RE: 407 TRANSITWAY (KENNEDY ROAD TO BROCK ROAD)
TRANSIT PROJECT ASSESSMENT PROCESS (5.10)

SUBJECT: 407 Transitway (Kennedy Road to Brock Road) Transit

To provide Council with comments and staff recommendations on the Ministry of Transportation draft Environmental Project Report for the 407 Transitway (Kennedy Road to Brock Road).

McCowan Road Station - Site Alternatives ATTACHMENT 'B-1'

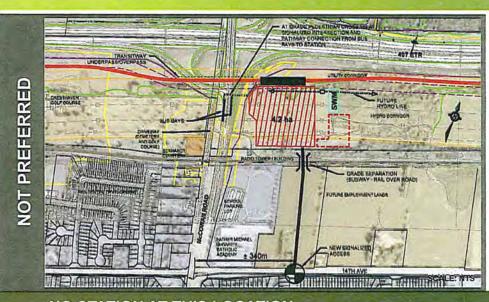
Metrolinx in their "Big Move" study denoted McCowan Road as a potential north-south transit corridor from Markville Mall to Scarborough Town Centre. McCowan Road may become a major transit corridor and City staff recommend that a future station at McCowan Road be provided for and implemented to service area residents / businesses even if it is a smaller station facility.

- b) That the Ministry of Transportation provide for an additional future station at McCowan Road, and include the preliminary design of the station as part of the EA.

Ninth Line Station - Site Alternatives

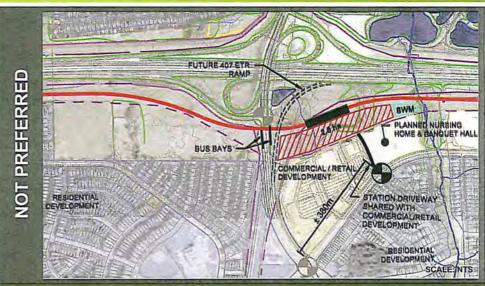
City staff are in general support of this location subject to implementation of noise protection for the residential community immediately south of the facility, no vehicular access through the residential neighbourhood, as well as identifying and resolving any traffic infiltration issues and impact to the south due to the station access at Ninth Line and Rouge Bank Drive.

- c) That the Ministry of Transportation work with the City to restrict vehicular access to the Ninth Line Station through the residential neighbourhoods and resolve any traffic issues resulting from the station access from Old Ninth Line.

- d) Mitigation of noise and other possible impacts to abutting residential properties at the Ninth Line Station.
 - e) That the Ministry of Transportation relocate the Donald Cousens Parkway Station on the east side of Reesor Road, adjacent to the future GO service on the Havelock Subdivision rail line.

Station Alternatives – Second Screening **Donald Cousens Station Evaluation**

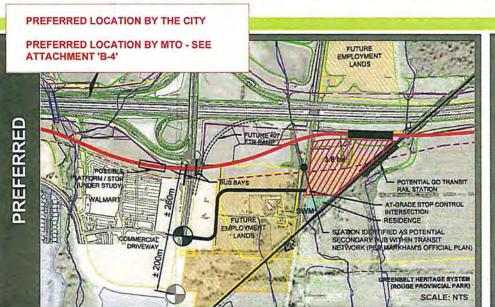
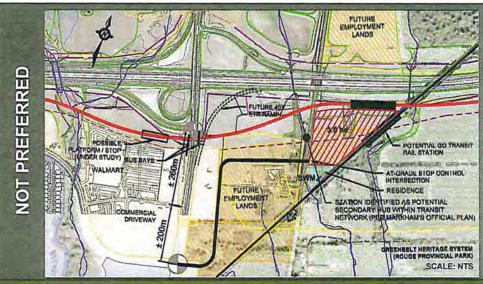
PREFERRED LOCATION BY MTO CITY PREFERRED LOCATION - SEE ATTACHMENT 'B-5'

Donald Cousens Station - Site Alternatives ATTACHMENT 'B-5'

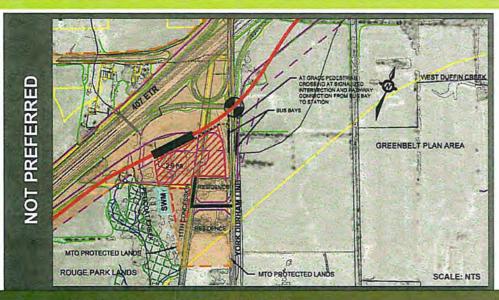
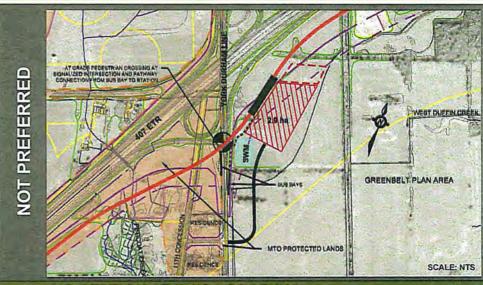
It is anticipated that GO service on the Havelock Line may be in place prior to the 407 Transitway. Staff recommend that the station facility be relocated to the east side of Reesor Road as per Attachment 'B-5' to integrate both the future GO and 407 Transitway transit service. Markham's Official Plan has identified the area east of Donald Cousens Parkway, south of the 407 ETR and adjacent to the CP Havelock rail line as a potential Secondary Hub.
